Exie Solar, LLC
Responses to Siting Board Staff's First Request for Information
Case No. 2025-00151

Site Assessment Report

Exie Solar Project

Case No. 2025-00151

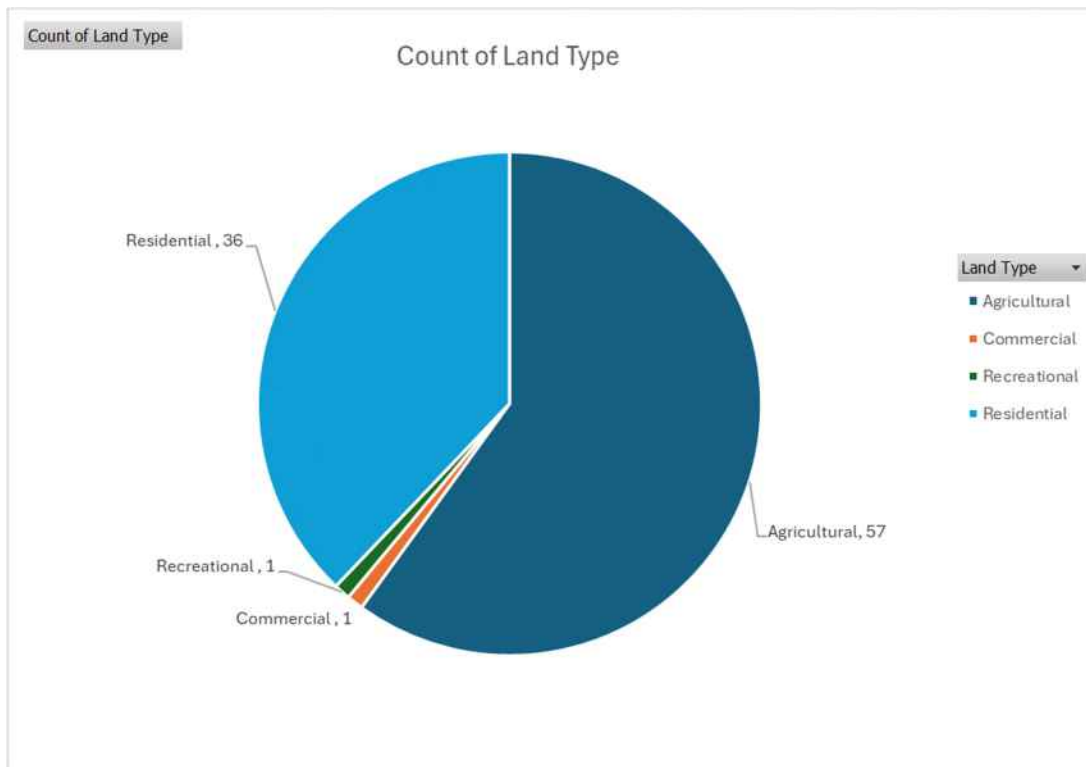
Refer to the SAR, Section 2.1. Commercial and recreational surrounding land uses are less common than agricultural, residential, and industrial land uses for most solar projects in Kentucky. Please provide additional information regarding the makeup of these surrounding land uses.

Please see below for a table and pie chart for the proportional number of parcels abutting the Project by land use type.

Land Use Category	Count by Land Type
Agricultural	57
Commercial	1
Recreational	1
Residential	36
Grand Total	95

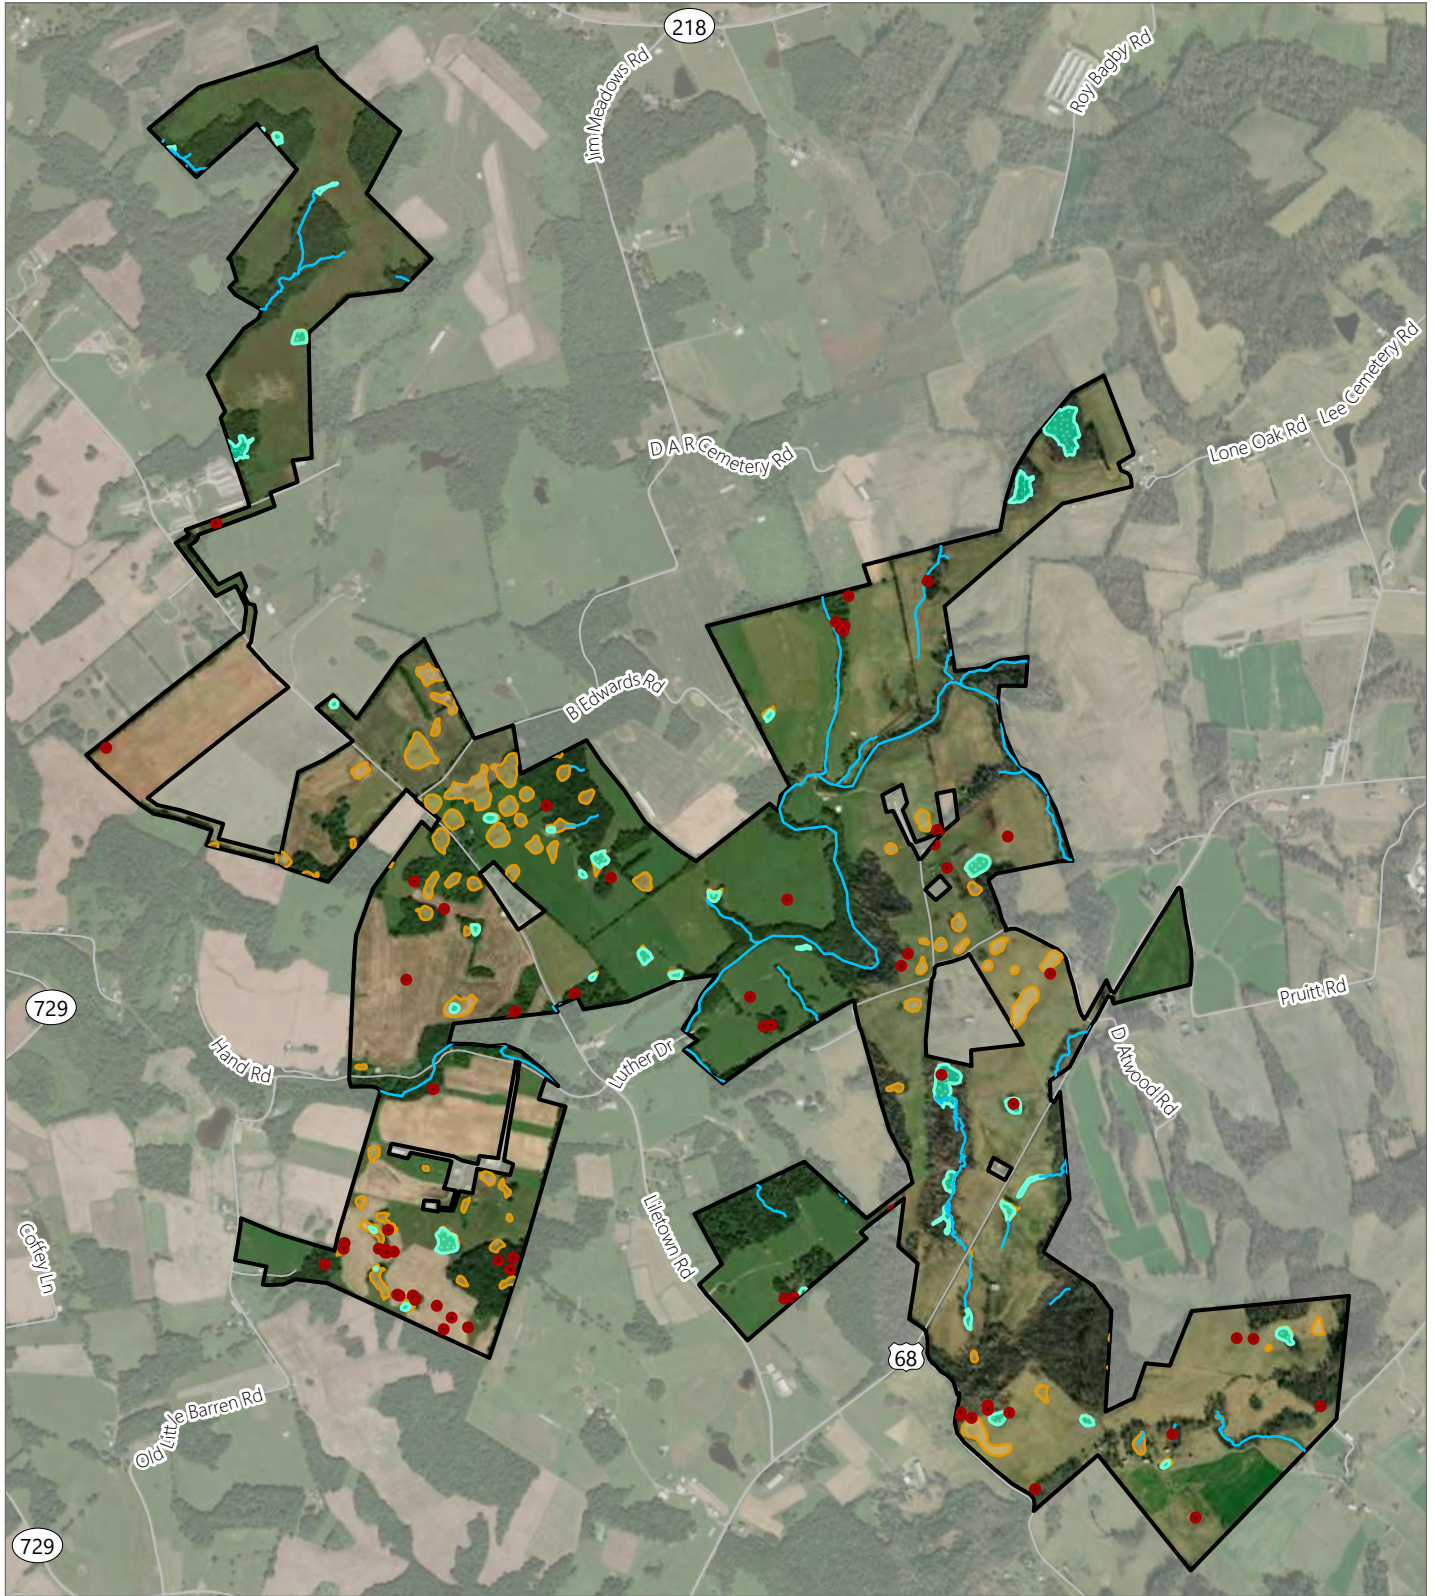
Provide a one-page site map that contains the locations water features, including rivers, streams, lakes, and ponds. Also include any known or suspected karst features.

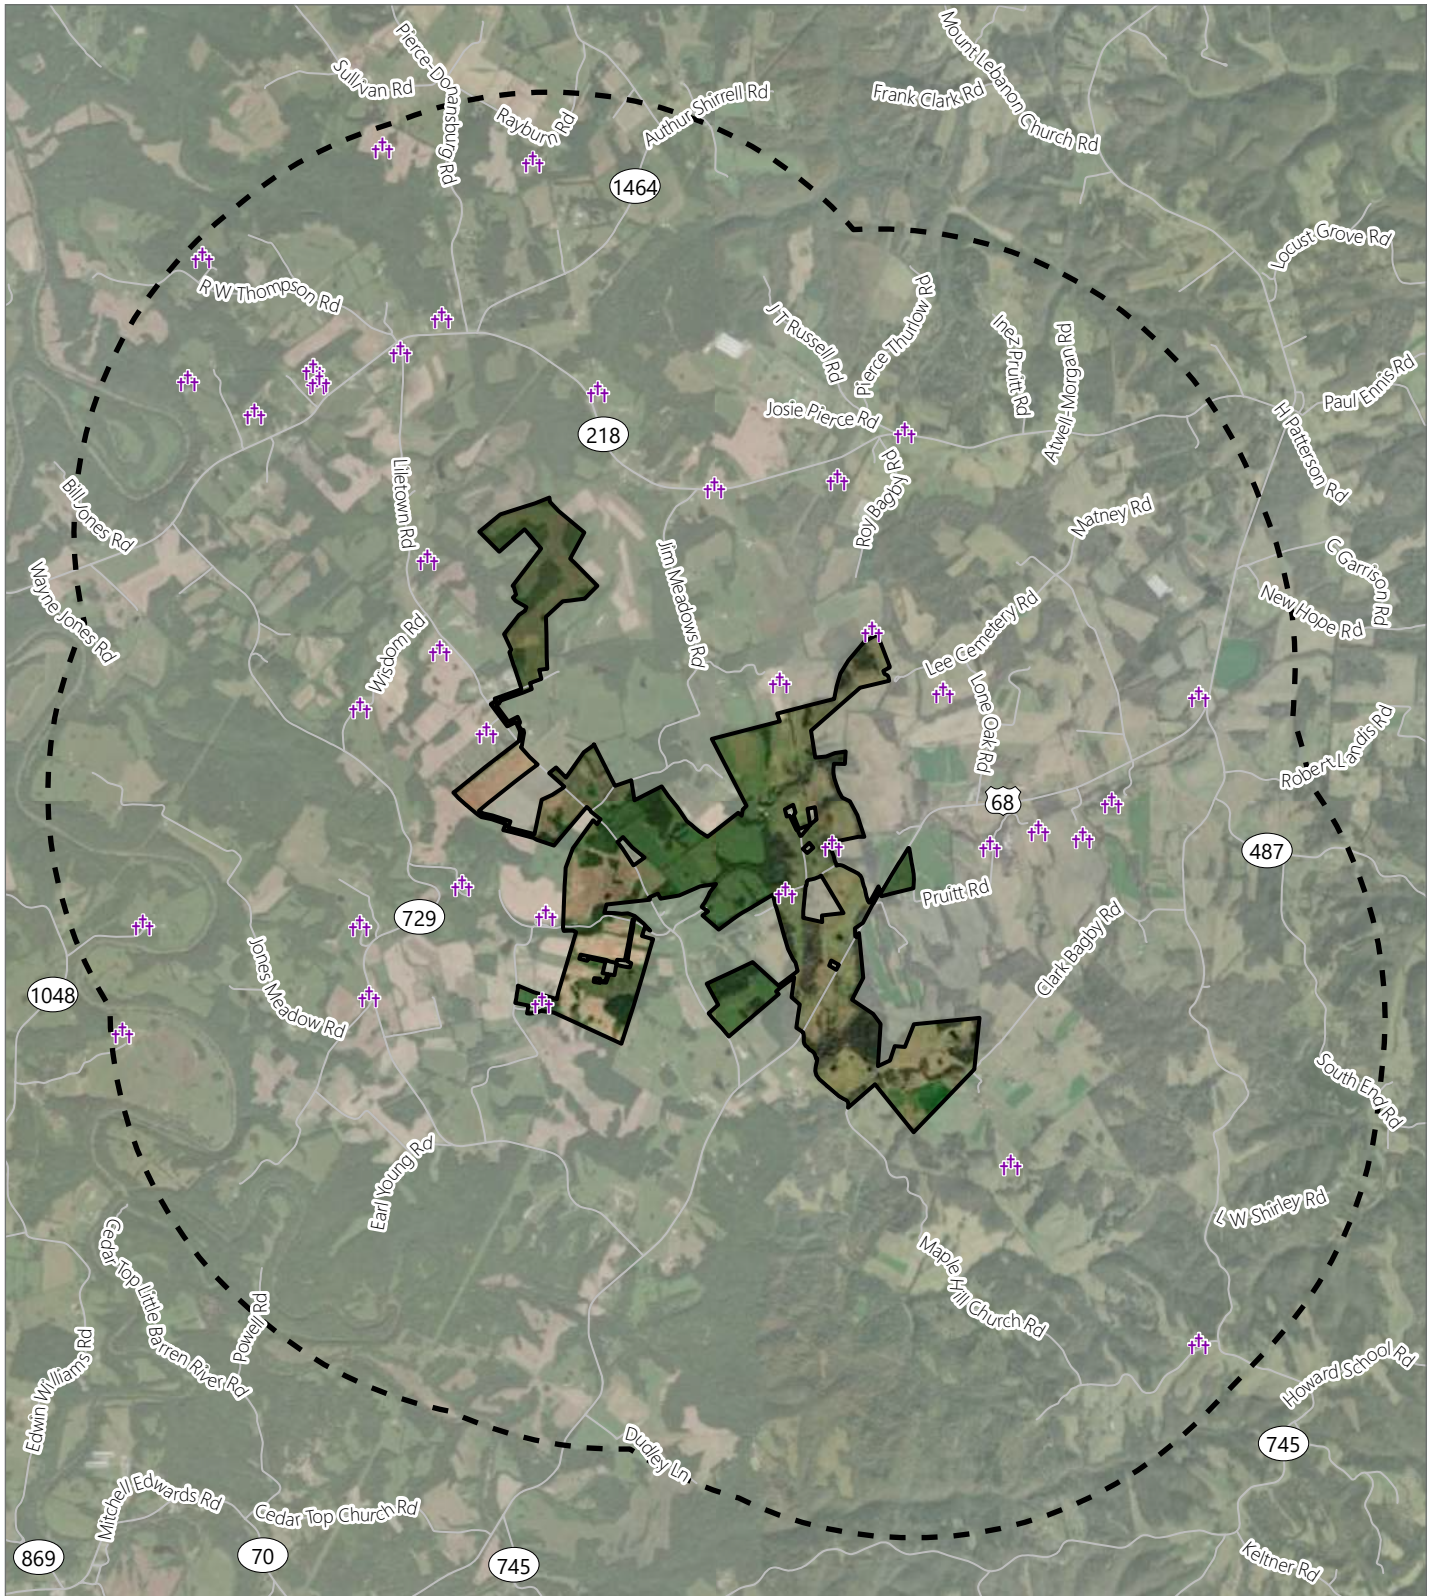
Provide a map and identify all cemeteries located within a two-mile radius of the project and provide if the project will restrict access to them in any way.

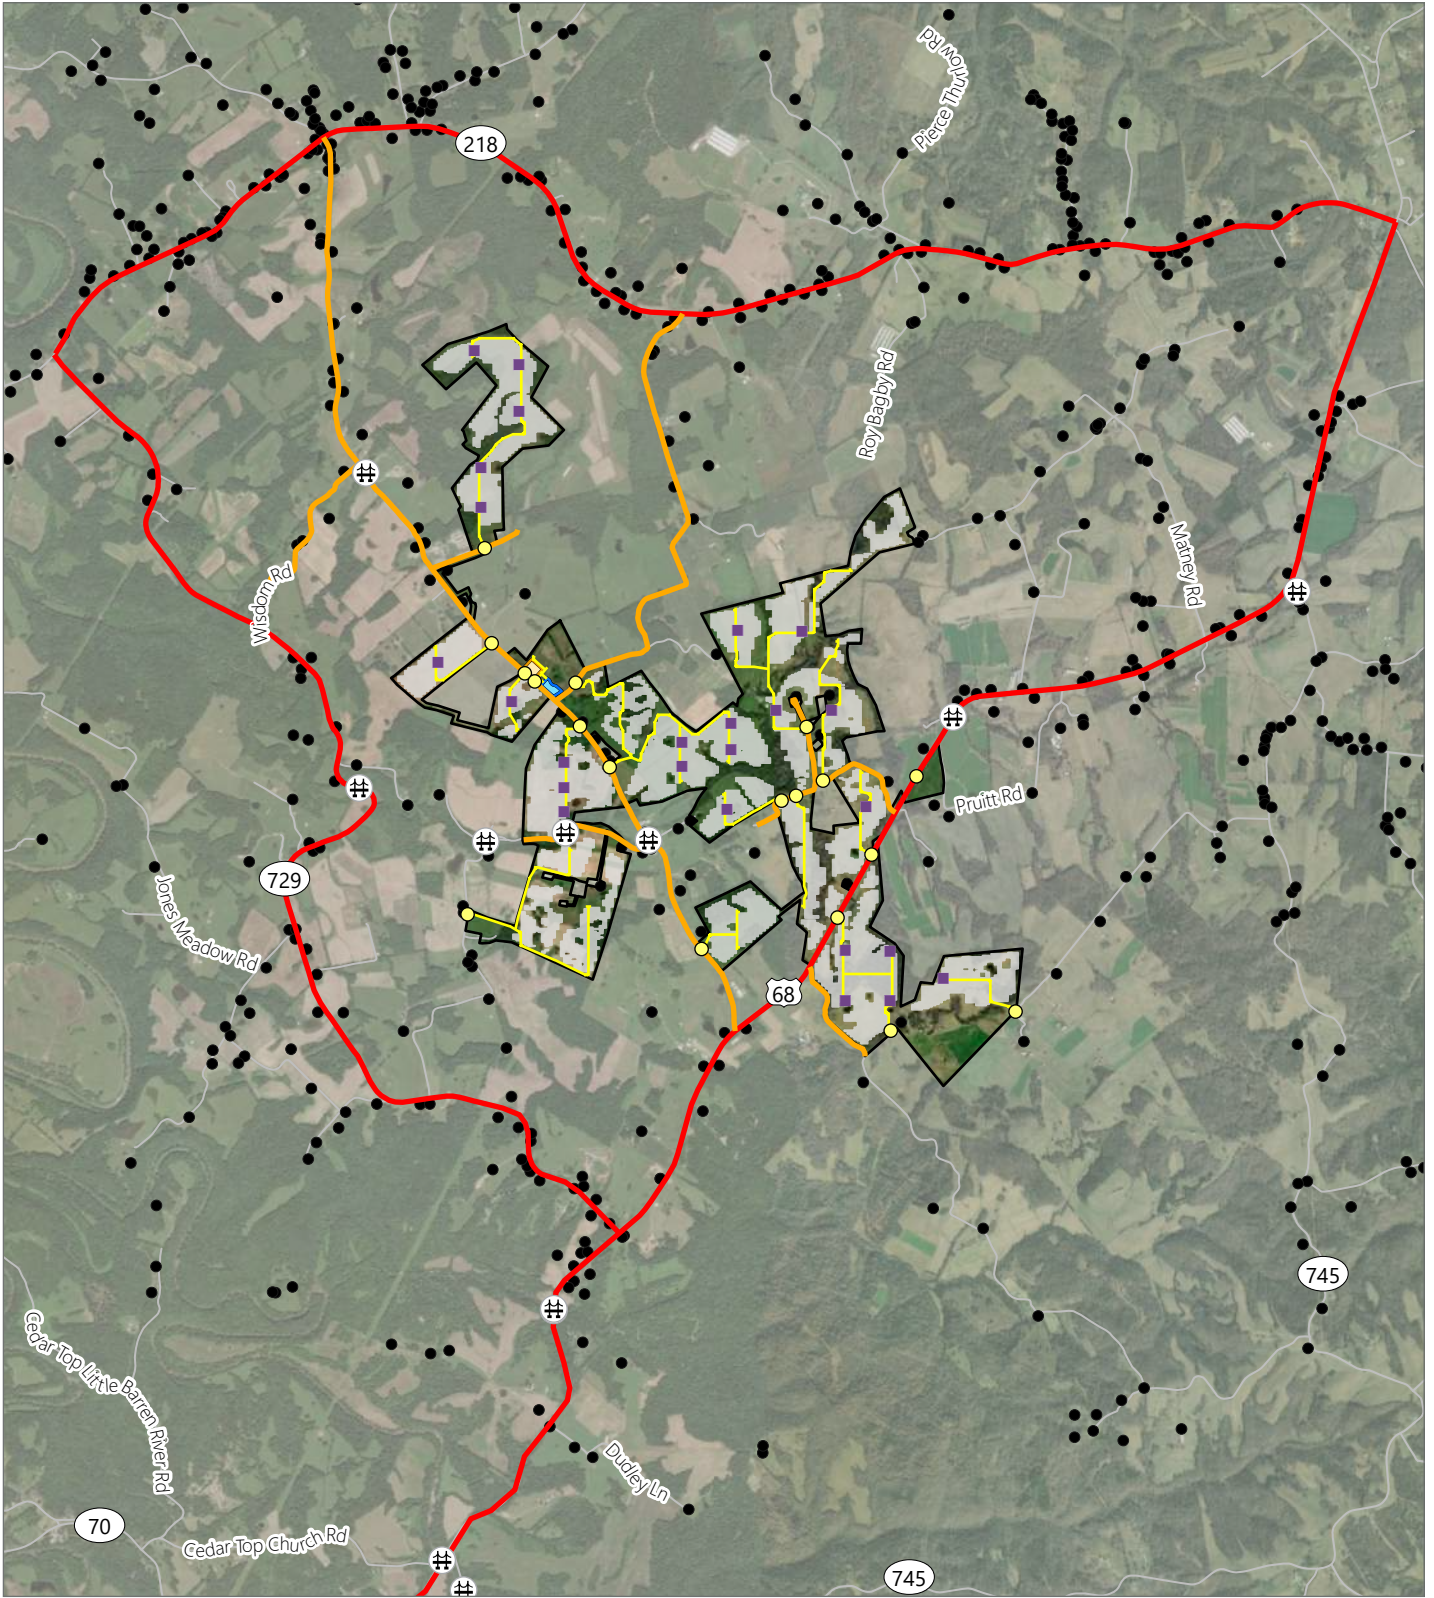
Provide a one-page directional map showing highlighted anticipated delivery routes for the project. Include on the map: access roads, access points, existing roads, bridges, electric generation components, and all structures within two miles of the project. Differentiate between roads and bridges that will and will not be used for deliveries.

See the map attached to Response No. 49 above.

DATE: 05/23/2025
 SHEET: C702

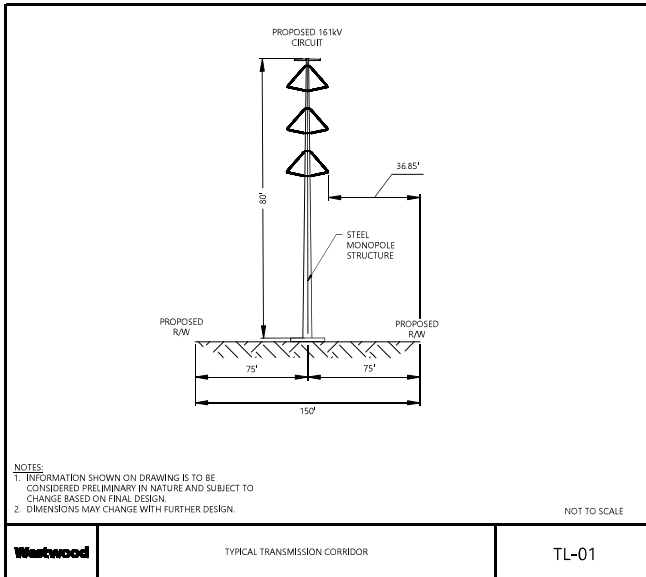
Provide any sketches of the proposed transmission line support structure.

- I. THE MINIMUM CONDUCTOR-TO-GROUND CLEARANCES UNDER MAXIMUM OPERATING CONDITIONS.**
- 161 KV LINE: 22.5 FEET.
 34.5 KV LINES: 22.5 FEET.
- J. INFORMATION CONTAINED ON DRAWING IS TO BE CONSIDERED PRELIMINARY IN NATURE AND SUBJECT TO CHANGE BASED ON FINAL DESIGN.**

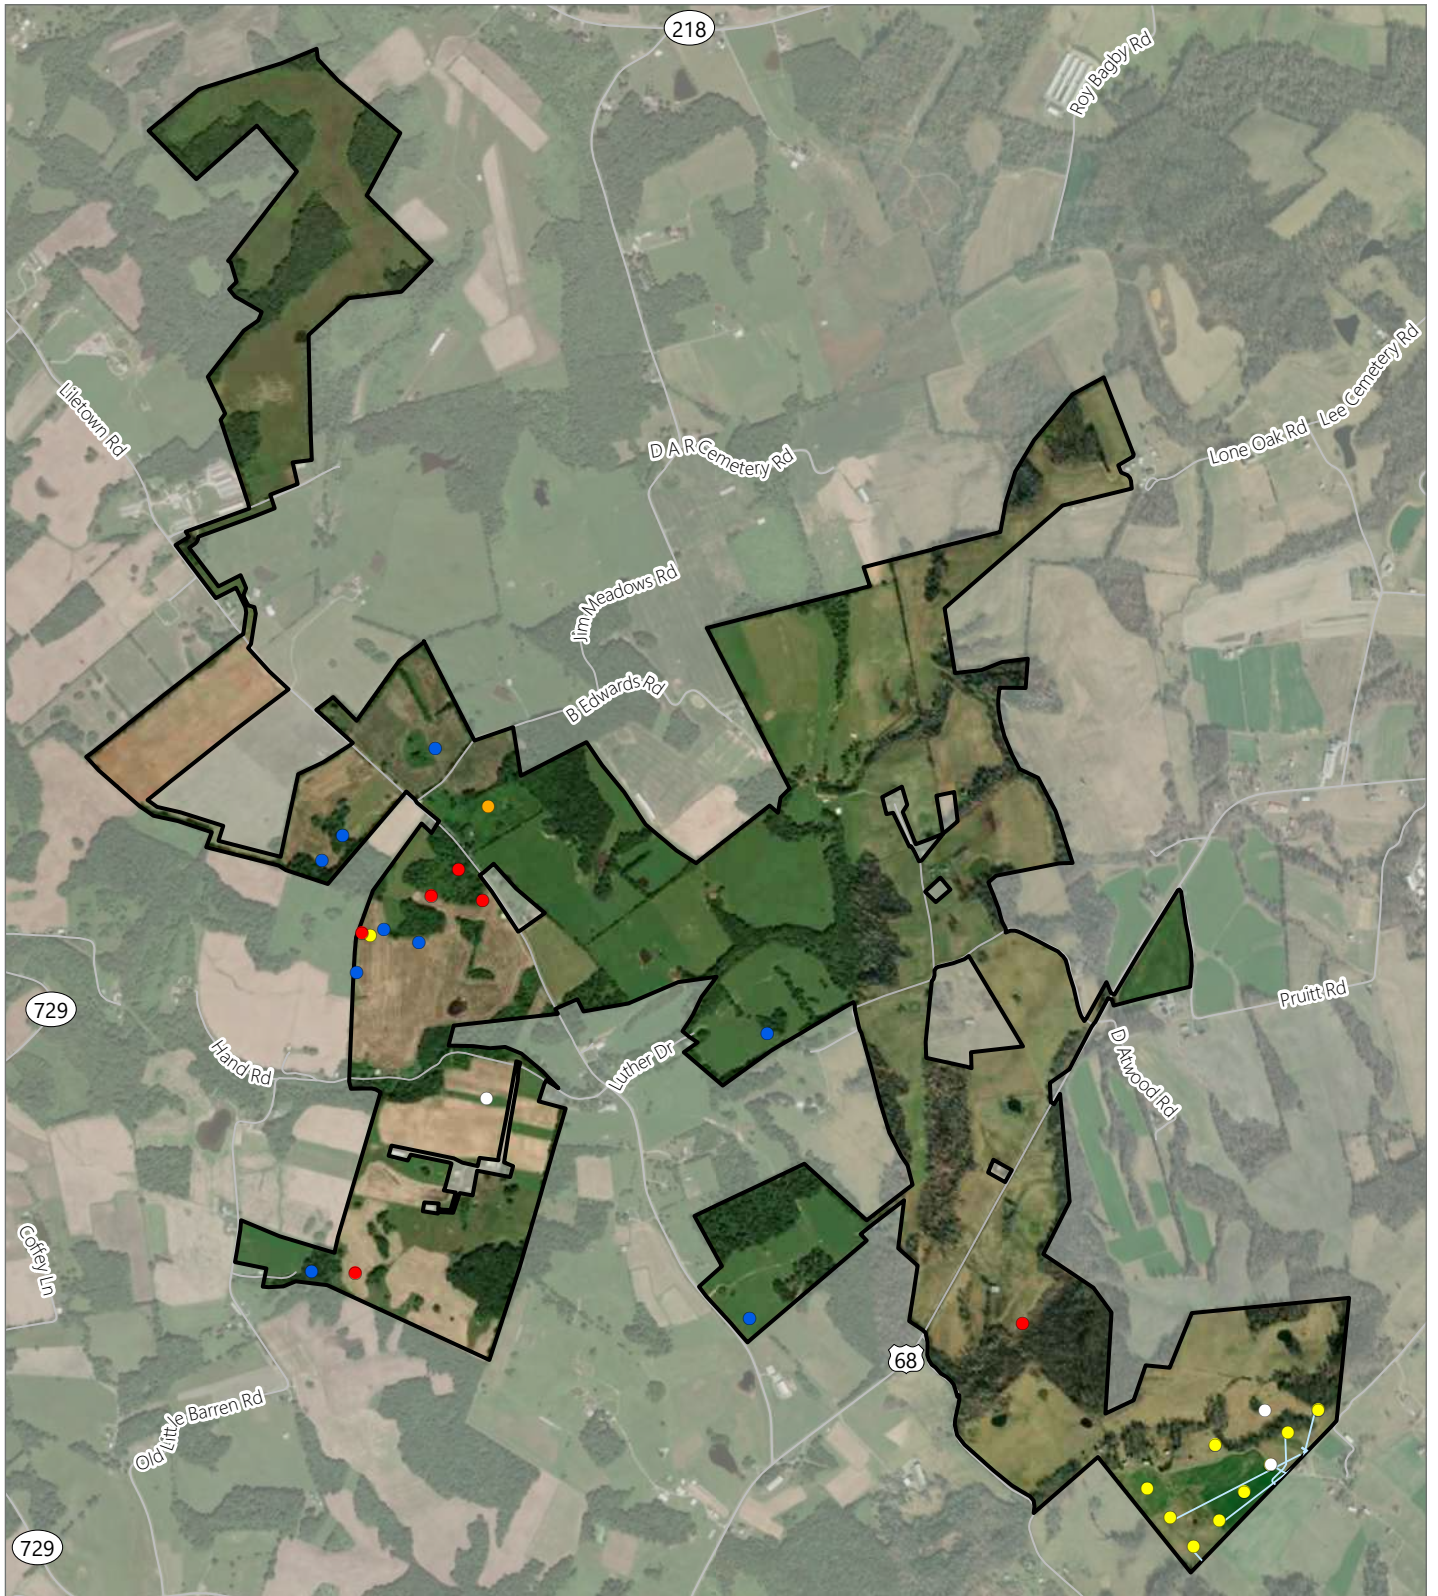
- a. Provide a map with all active and inactive oil or gas wells on the proposed site. Also include any gas-gathering pipelines associated with the wells.
- b. Determine and identify whether any of these wells are currently permitted and active.
- c. Explain whether the existence of oil and gas wells and pipelines will require adjustments to the proposed location of solar panels.
